**1601 E AMERICAN BLVD
HILTON GARDEN INN - CORRIDORS & GUEST RO**

Originating Department Community Development	By GPD	Approved for Agenda by:	Date: Time:	Number:
Agenda Section DEVELOPMENT BUSINESS		Item Rezoning, Preliminary and Final Development Plan

Case 9294A-97

Applications for Rezoning to FD-1 Planned Development (PD)
Preliminary and Final Development Plan
to Allow Construction of a 202-Unit Hotel on 4.8 Acres of Land

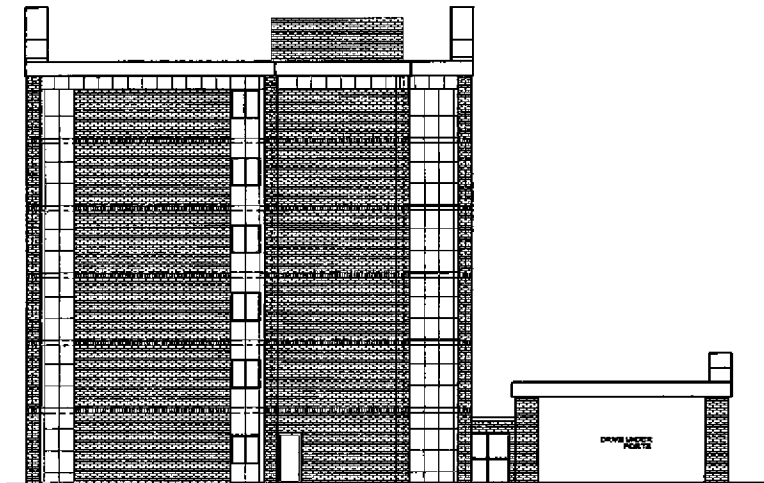
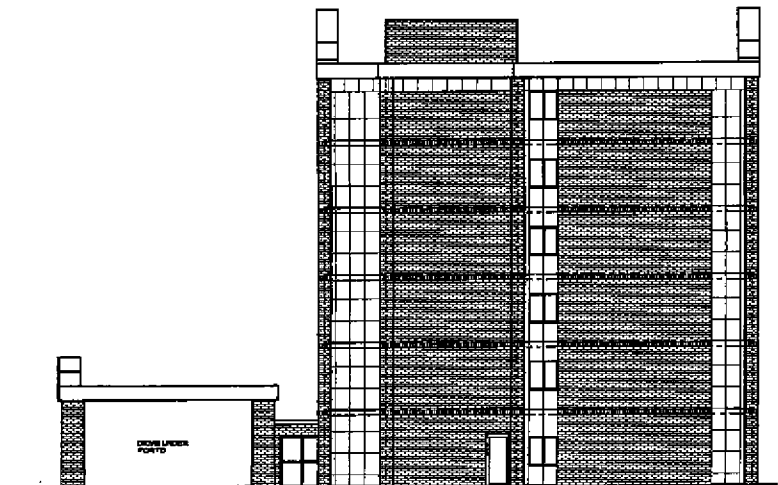
Revised hotel building elevations now show an exterior finish of three types of brick and have eliminated the use of any noncomplying materials. Staff does have some concern over the proposed elevations and will be discussing additional detailing with the developer to break up the long rectangular facades.

- 3) Exterior building materials and building elevations be approved by the Planning Manager;
- 4) Building plans shall identify trash and recyclable material collection and storage area provided within the building as approved by the Fire Marshal and the Planning Manager;
